Access Compliance Report

Public Rights-of-Way

(Curb Ramps)

Intersection ID: 50585	Main Street: GRAND_FIR_RD	Cross Street: BENDING_BRANCH_RD	Location: NW
ADA ID: 447138AC3341	Ramp Type: Perp	Initial Pass/Fail: Fail	Overall Compliance: No
Severity Score: 21.25			
Codes/Mitigation Info/Possible Solution		Field Measurements/Component Compliance

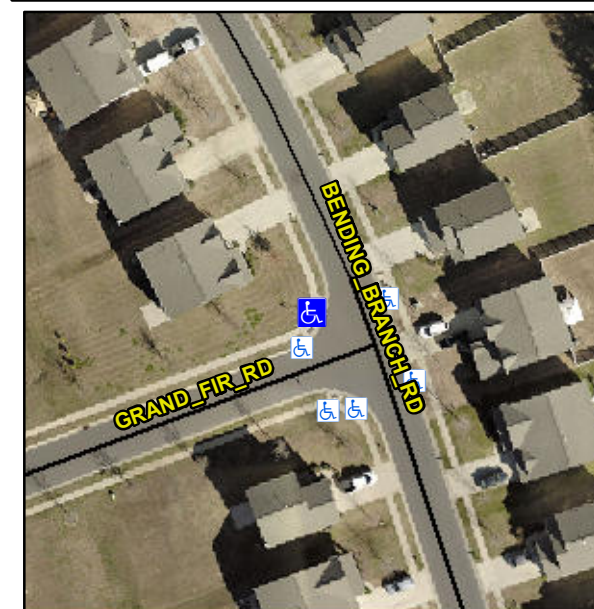
Not Found, R304.5.1, R304.2.2

Compliance	Description	Data	Compliance	Description	Data
N/A	Ramp Length (in)	51.5	No	Ramp Slope (%)	11.1
No	Ramp Width (in)	46.5	Yes	Ramp XSlope (%)	1.9
N/A	Flare Type LT	N/A	N/A	Flare Type RT	N/A
N/A	Flare Slope LT (%)	N/A	N/A	Flare Slope RT (%)	N/A
N/A	Flare Traversable LT?	N/A	N/A	Flare Traversable RT?	N/A
N/A	Landing Length (in)	N/A	N/A	DWS Provided?	N/A
N/A	Landing Width (in)	N/A	N/A	DWS Contrast?	N/A
N/A	Landing Slope (%)	N/A	N/A	DWS Length (in)	N/A
N/A	Landing X Slope (%)	N/A	N/A	DWS Full Width?	N/A
N/A	Landing Curb? (Y/N)	N/A	N/A	DWS Offset (in)	N/A
N/A	Shared Landing?	N/A			
N/A	Gutter Ponding?	N/A	N/A	Gutter Slope (%)	N/A
N/A	Gutter Lip Ht (in)	N/A	N/A	Gutter X Slope (%)	N/A
N/A	Painted X Walk1?	No	N/A	Painted X Walk2?	N/A
	X Walk 1 Direction	To E		X Walk 2 Direction	N/A
N/A	X Walk 1 Width (in)	N/A	N/A	X Walk 2 Width (in)	N/A
	X Walk 1 Slope (%)	1.8		X Walk 2 Slope (%)	N/A
	X Walk 1 X Slope (%)	2.7		X Walk 2 X Slope (%)	N/A

Remove & Replace Entire Ramp.
